May 18, 2007

RE: P0323567
Textron Inc. Temporary Trailer
2865 Front Street
Slidell, La. 70458

REVIEWED FOR
STATE FIRE MARSHAL
AS PER REVIEW LETTER
BY: WILLIAM LEE JENSEN, ARCHITECT

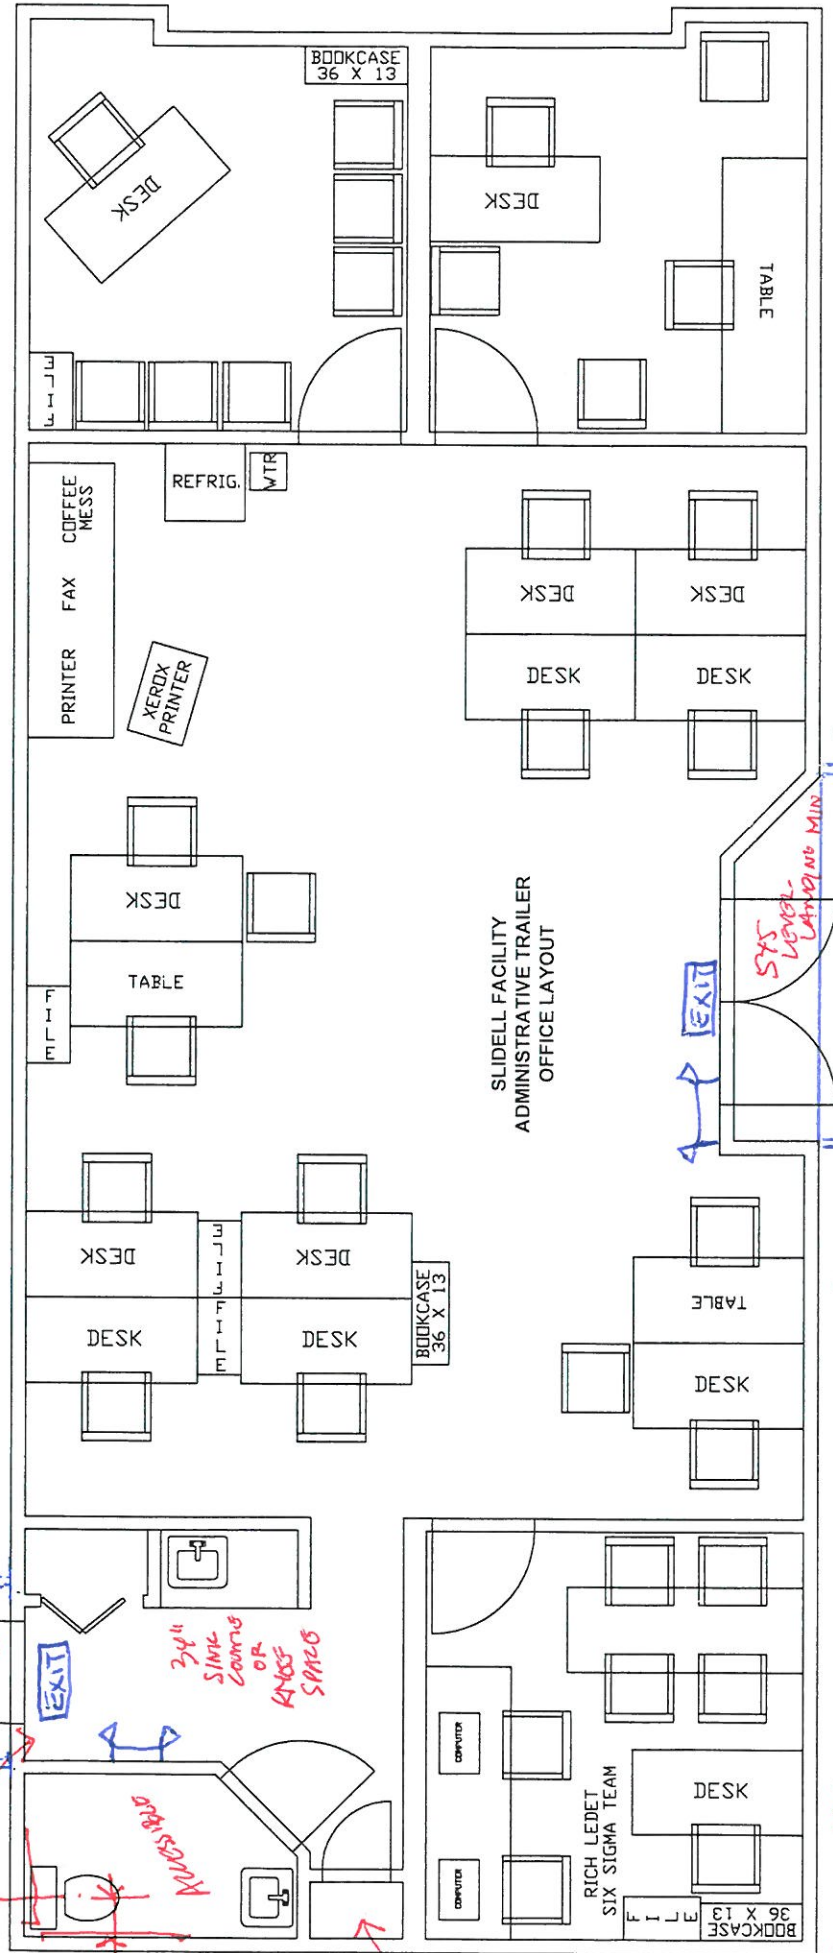
65 TOPSHEET = 42" PRINTED
PLANT TO GRADE DISTANCE
INDICATED
ALL OPEN SIDES,
MIN. LATERALS
3' X 2'
6" MIN. LATERALS
6" MIN. LATERALS
ON ALL OPEN SIDES

STAIN DIRECTING
R/C TO OTHER
EXIT

INCIDENTAL STORAGE
OF CUSTOMARY OFFICE SUPPLIES? OR CONSTRUCTION
